ORIGINATION FORM

Proposed Revisions to a Standard Plans Index

Index Number: 550-012
Sheet Number (s): 3 of 4
Index Title: BRIDGE FENCING (ENCLOSED)

INDEX	SHEET
550-012	3 of 4

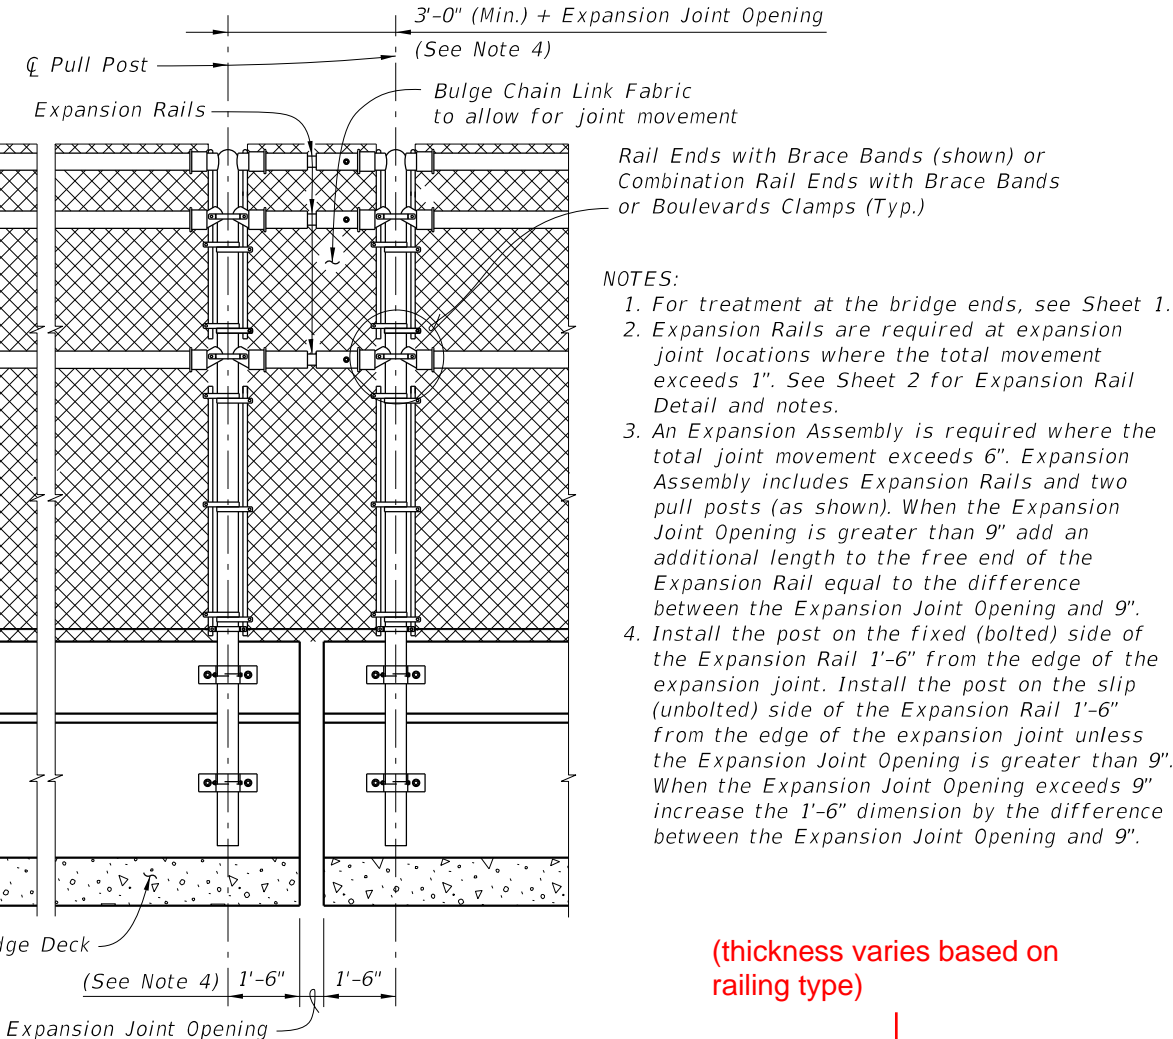
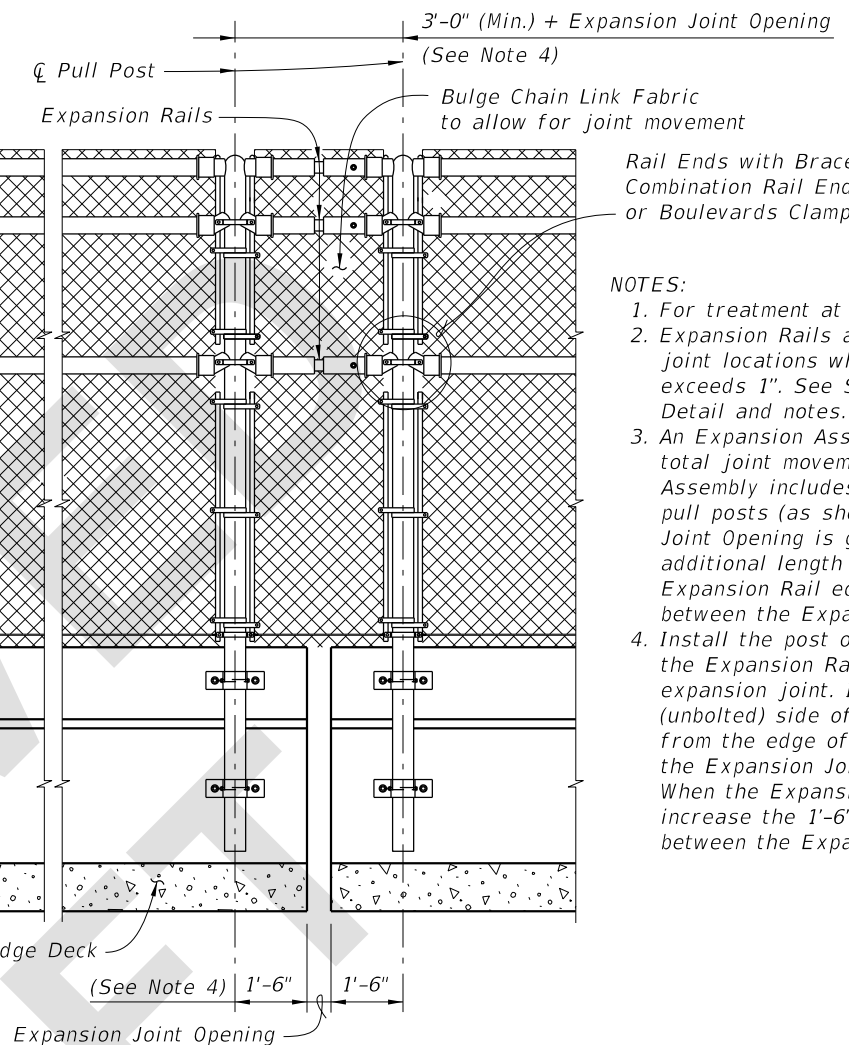
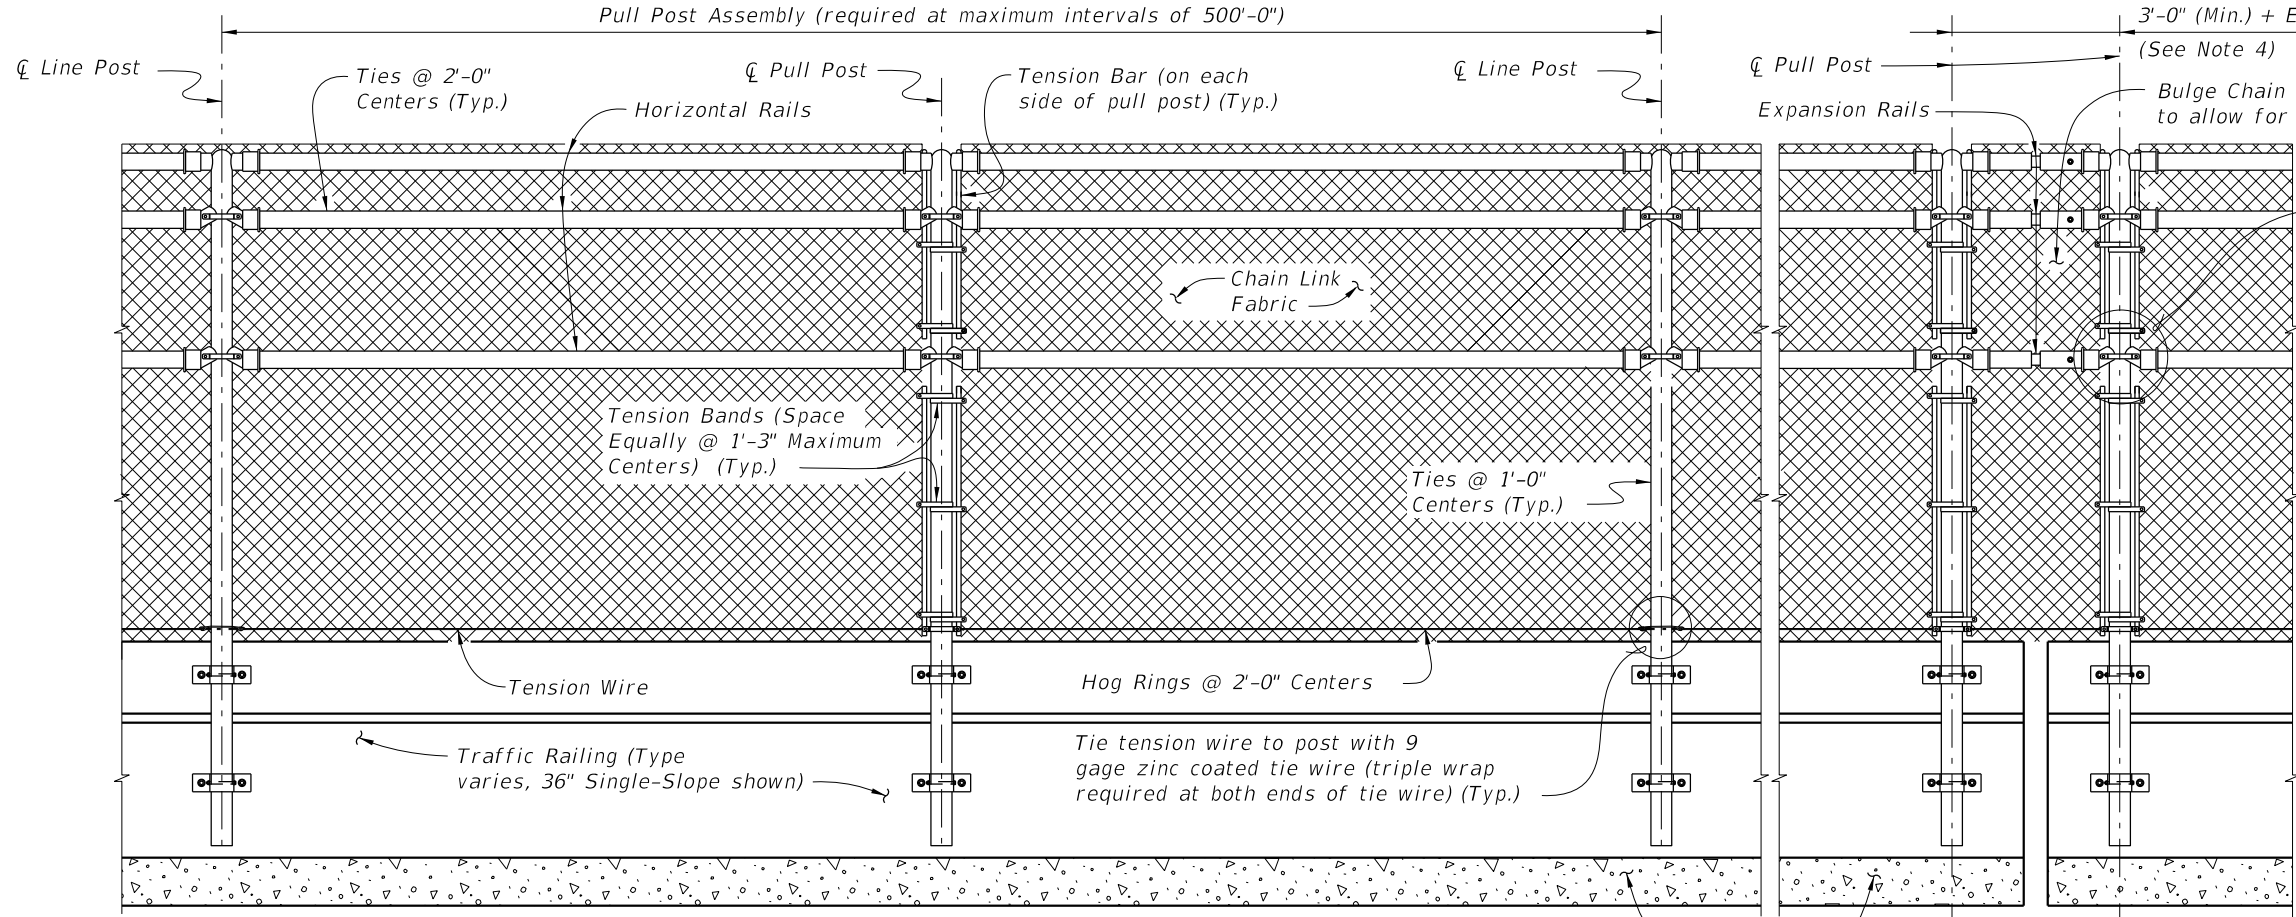
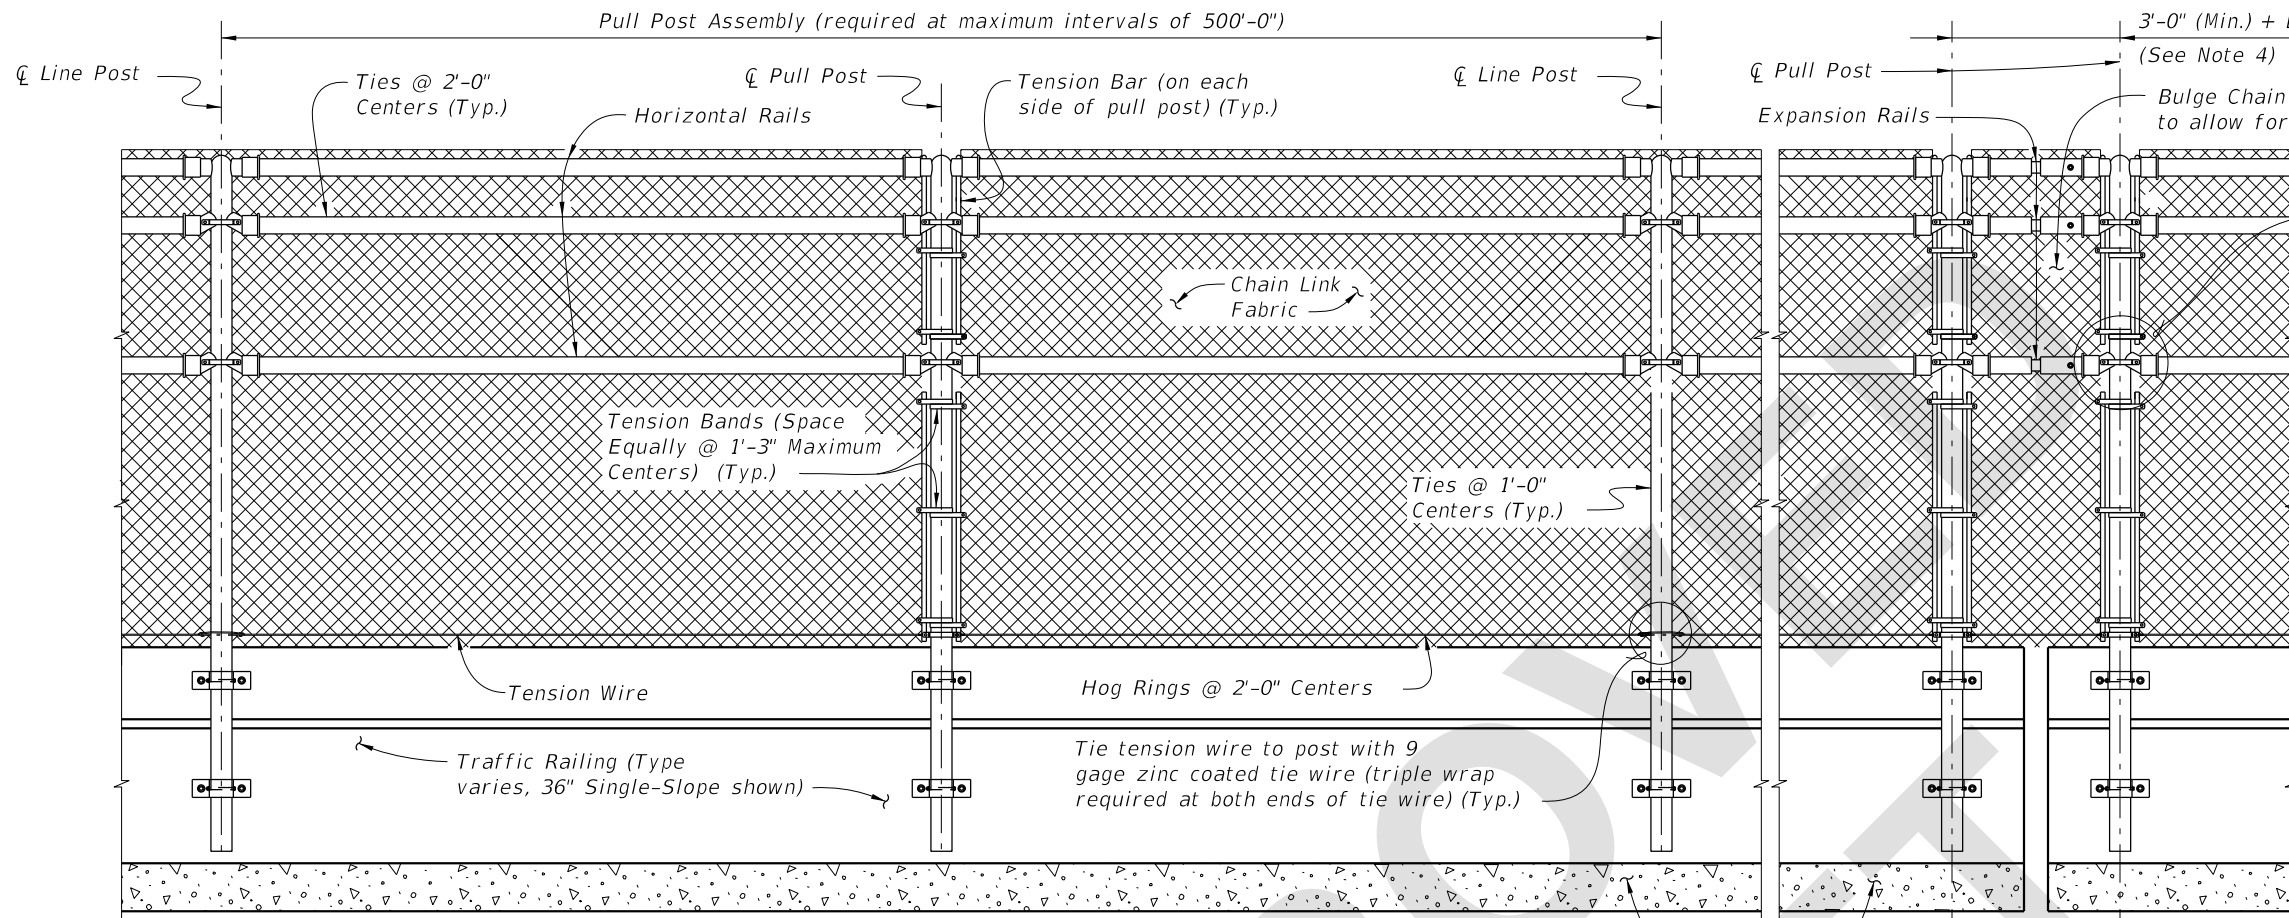
Sheet 3: Change the shim thickness at the base of the pole to indicate that it varies based on railing type.
